Groundwater Application Review Summary Form

Application # G- 18793

To: Kristopher Byrd, Well Construction and Compliance Section Manager
From: Joel Jeffery, Well Construction Program Coordinator
Subject: Review of Water Right Application G-18793
Date: October 29, 2019

TO: Water Rights Section Date October 14, 2019
 FROM: Groundwater Section Aurora C Bouchier
 SUBJECT: Application G- 18793 Supersedes review of na
 Reviewer's Name
 Date of Review(s)

Water-Level Trends in Nearby Wells

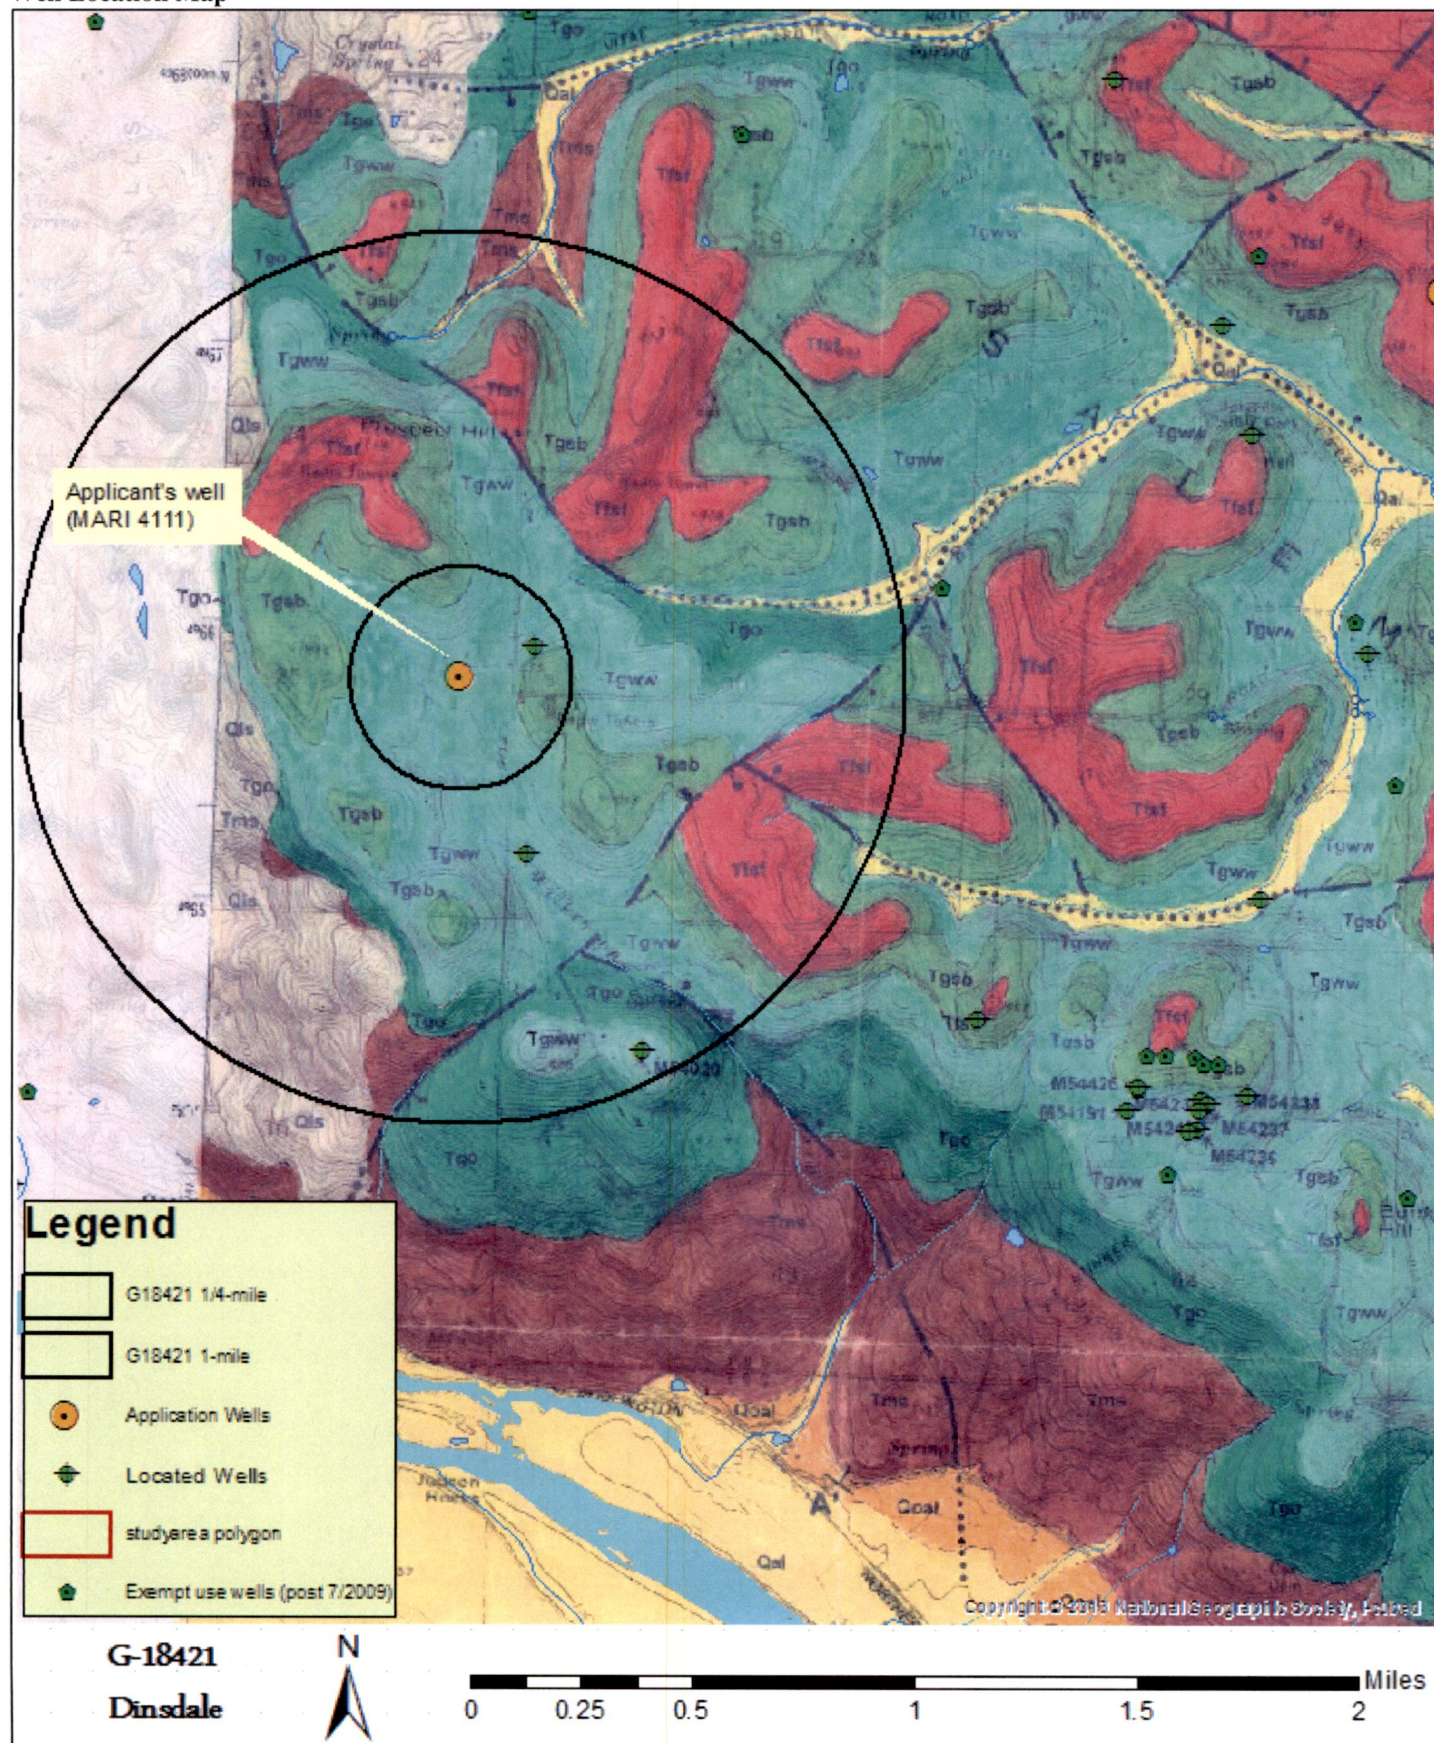
Limited groundwater elevations in the area make it difficult to long-term trends, although elsewhere in the South Salem Hills the relatively stable water levels show no significant losses in head within the CRBG aquifers at the current level of use. However, the universally low storativity of CRBG aquifers limit their potential productivity, both in rate and total volume.

FIGURE 3.—Diagrammatic section showing downward migration of ground water through unlined parts of wells that tap the basalt.

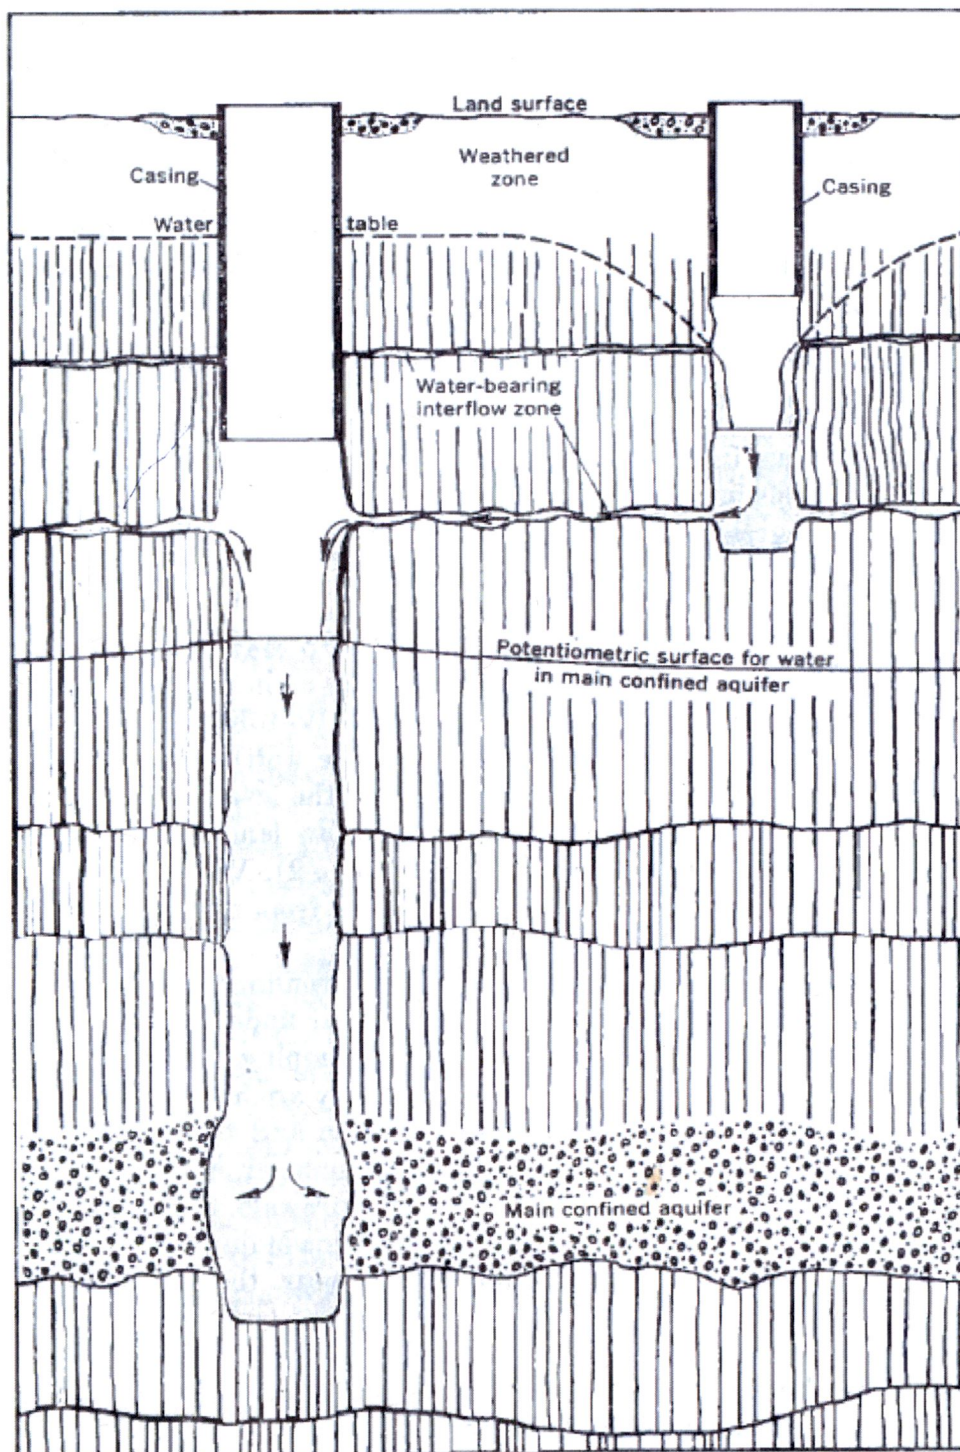
Constructing a well that is open to multiple water-bearing zones with distinct water level heads can commingle multiple aquifers (see diagram from Foxworthy, 1970 at end of review). When the pump is off, water migrates through the well bore from an aquifer of higher pressure to an aquifer of lower pressure. Over time, this can depressurize the aquifer and exacerbates water level decline. Well construction conditions are specified to protect the resource and other existing users.

Basis for aquifer confinement evaluation: Based on the well log for the applicant's well (MARI 4111) the driller encountered water from 98 to 313 feet, with a static water level of 155 feet. Based on other well logs in the area (MARI 4180 and MARI 54020) one would expect confined conditions with static water levels rising to some extent above the zone at which the water was encountered. It appears that this well is (or at least was at the time of construction) open to water-bearing zones above the main confined aquifer (see diagram from Foxworthy, 1970 at end of review).
